**Flood Control Project Maintenance
Levee Inspections**
LMA District Cover Sheet
Spring 2016 Levee Inspection Results

Reclamation District No. 2085 Kasson

Spring 2016 Levee Inspection Results

Levee Inspection Report By Mile - Spring 2016

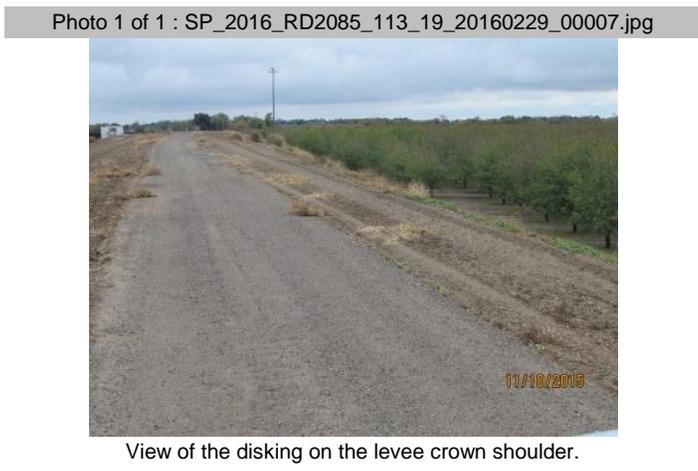
LM Start		Rating **	A	Issue No.	14
LM End		Issue Type +	Ma	Location *	N/A
Category	Earthen Levee			GPS Latitude/Longitude	
				Start	End
Item	Flood Preparedness & Training			o	o
DWR ID	DWR_RD2085_01_s_2013_14				
Comment Code					
Inspector Comment					
The LMA has a flood fighting plan and training.

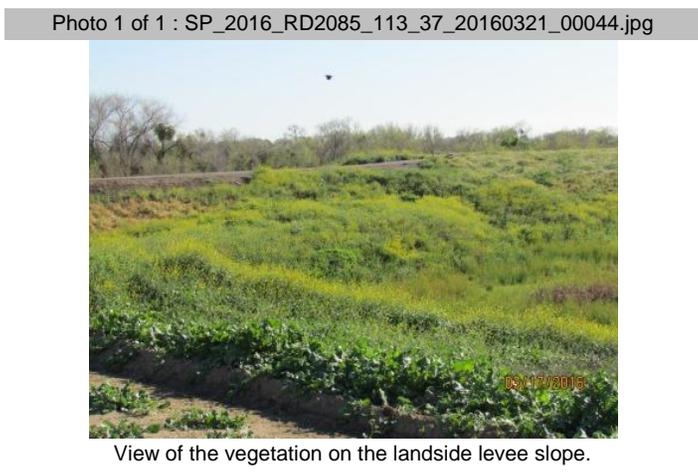
LM Start	0.49	Rating **	M	Issue No.	37
LM End	0.64	Issue Type +	Ma	Location *	LS
Category	Earthen Levee		GPS Latitude/Longitude		
			Start	End	
Item	Vegetation		37.723429 °	37.722477 °	
			-121.299313 °	-121.296956 °	
DWR ID	DWR_RD2085_01_s_2016_37				
Comment Code					
V1 : Control annual grass and weeds on the levee slopes and easements.					
Inspector Comment
